Re: McGuire Nuclear Station
Docket Nos. 50-369, 50-370

RESPONSE TO NRC
REQUEST FOR ADDITIONAL INFORMATION
DUKE POWER COMPANY'S PROPOSED
INADEQUATE CORE COOLING INSTRUMENTATION FOR
MCGUIRE NUCLEAR STATION UNITS 1 AND 2

Attachment 4
McGuire Nuclear Station - Unit 1
Reactor Vessel Level Instrumentation System
Implementation Letter

McGUIRE UNITS 1 & 2 CONTROL ROOM LAYOUT

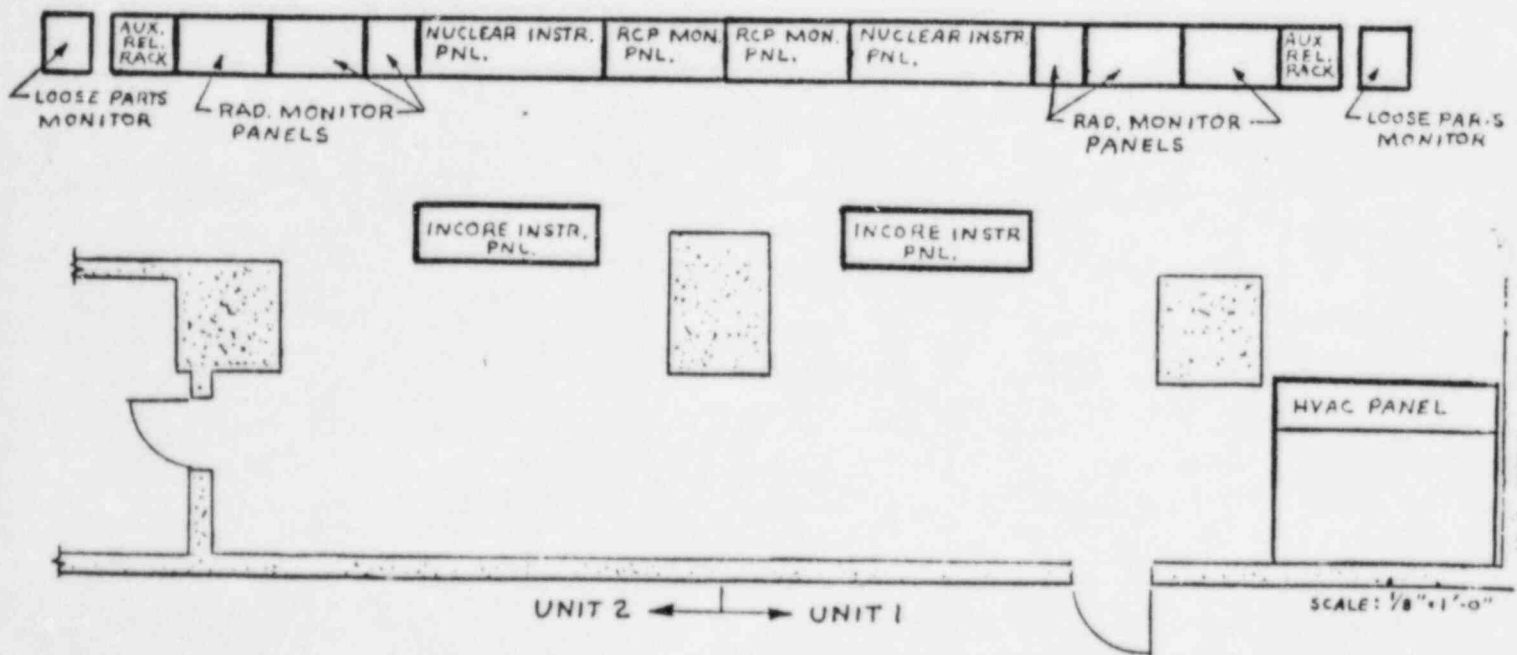
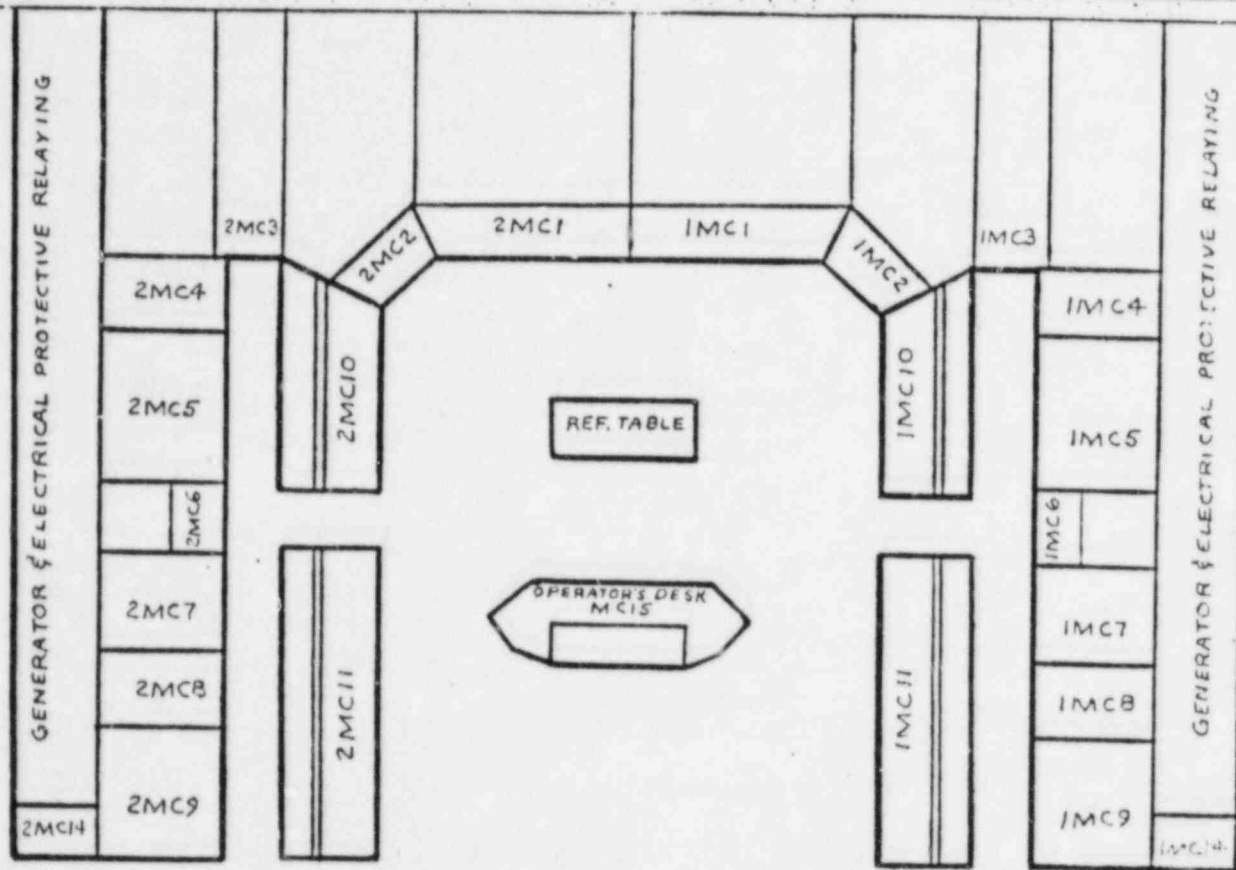
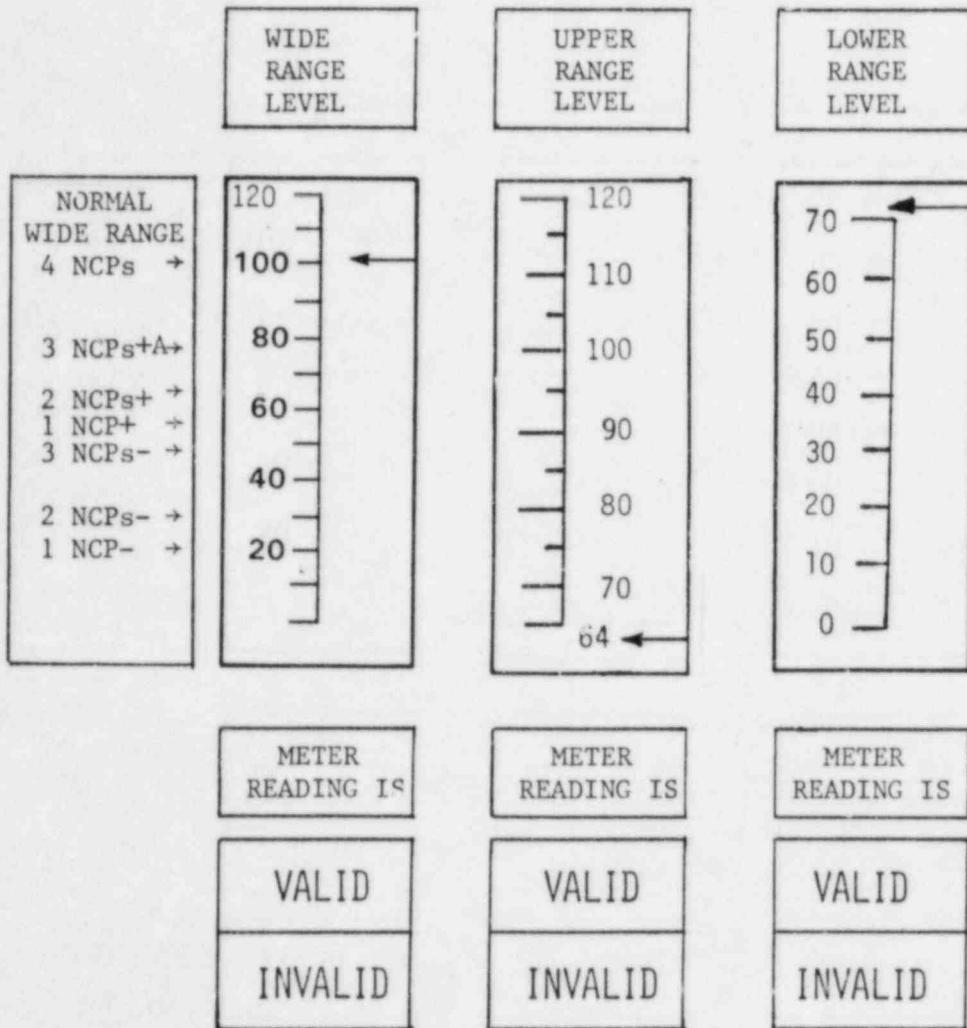
3. Provide a detailed description of the final integrated display system for ICC information indicated by the CETs, SMM, and RVLIS.

- 1) The primary display for the Incore Thermocouple System consists of a CRT graphic which can be displayed on monitors located on control boards MC1 and MC2 (see Attachment 3 for locations). This display generated through the plant Operator Aid Computer. The CRT graphics provide a spatially oriented core map available on demand indicating temperature at each of the 65 core exit thermocouple locations. The readout range extends from 200 degrees F to 2300 degrees F. Trending of selected thermocouple readings and hard copy printouts are available on demand. This display is non class 1E.
- 2) A Class 1E backup display will be provided on control board MC5. This display will have the capability of reading the upgraded thermocouples within a time interval of no greater than six minutes. The range of this display will extend from 200 degrees F to 2300 degrees F.

- 1) The primary display for the SMM is a CRT graphic which can be displayed on either monitors located on control boards MC1 and MC2. This display is generated through the plant Operator Aid Computer. The CRT graphics provide an on demand display of conservative margin to saturation conditions. In addition, each hot leg temperature, RCS pressure, power level, margin to Psat, each RCS loop margin to Tsat, thermocouple margin to Tsat, and the minimum allowable margins to Psat and Tsat are displayed.
- 2) In accordance with Duke Power's Control Room Design Review, an additional SMM display will be added to control board MC5. This display will provide subcooling margins for each of the four reactor coolant loops and the reactor vessel.

- 1) The RVLIS display consists of three Class 1E indicators (per train) located on control board MC8. Each of the three dp loops per train drive an individual control board indicator (see previous submittals for detailed description of RVLIS system and ranges). Each control board indicator has an associated indicating light located adjacent to it to indicate the valid/invalid modes, depending on reactor coolant pump operational status. (See Attachment 3)
4. Clarify the DPC position with respect to conformance to NUREG-0737 Item II.F.2 requirements for SMM, and provide a schedule for SMM upgrade.
